AMENDMENT OF SOLICITATION/MODIFICATION OF CONTRACT			1. CONTRACT ID CODE	PAGE 1 OF 6
2. AMENDMENT/MODIFICATION NO. A001	3. EFFECTIVE DATE June 17, 2014	4. REQUISITION/PURCHASE REQ. NO. PR3347197	5. PROJECT NO. (If applicable)

14. DESCRIPTION OF AMENDMENT/MODIFICATION (Organized by UCF section headings, including solicitation/contract subject matter where feasible.)				
The purpose of this amendment is to modify Attachment 1, Statement of Work to add tasks as stated below.				
Except as provided herein, all terms and conditions of the document referenced in Item 9A or 10A, as heretofore changed, remains unchanged and in full force and effect.				
15A. NAME AND TITLE OF SIGNER (Type or print)		16A. NAME OF CONTRACTING OFFICER Elizabeth Konick		
15B. NAME OF CONTRACTOR/OFFEROR BY _____ (Signature of person authorized to sign)	15C. DATE SIGNED	16B. UNITED STATES OF AMERICA BY  (Signature of Contracting Officer)	16C. DATE SIGNED 17 JUN 2014

ATTACHMENT #1

STATEMENT OF WORK

2. ATTACHMENT #2, DRAWING #2 is added.

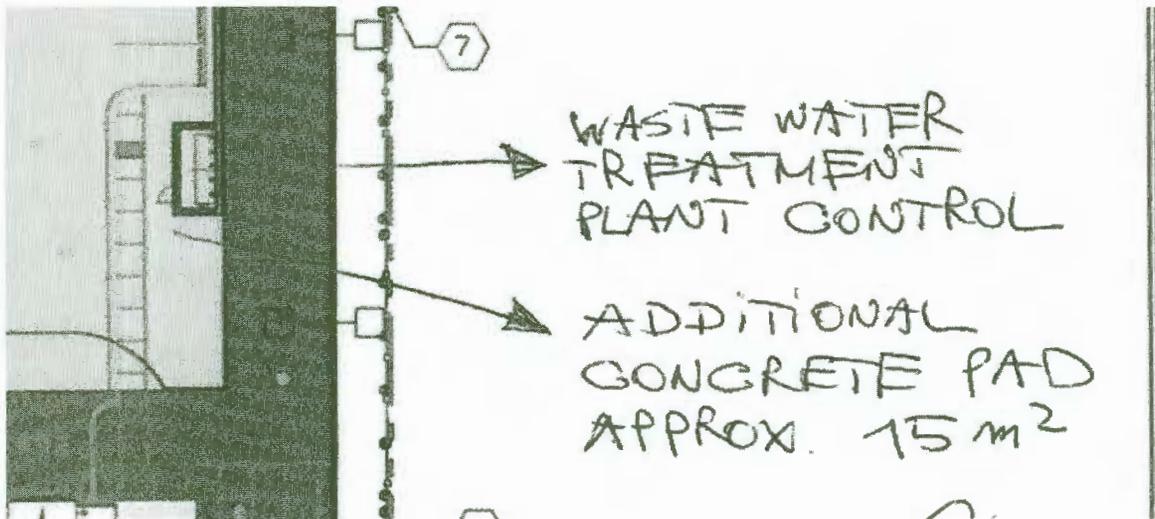
3.11 Waste water treatment plant slab

- 3.11.1 *The new slab will be 100mm thick, dimensions approximately 3,4 x 4,4 meters.*
- 3.11.2 *The ground under the slab will be excavated 200mm deep, back filled and compacted with clean 100mm base course.*
- 3.11.3 *Use 150x150 WWF as reinforcing steel for the slab.*
- 3.11.4 *The slab will have control joints same as the walkway adjoining it.*
- 3.11.5 *The finished surface will have a broom finish and finished edges.*
- 3.11.6 *The expansion joints will be sealed with a high quality weather proof sealant.*
- 3.11.7 *Reinstall the irrigation line control boxes (3+1), prior to casting the concrete slab.*
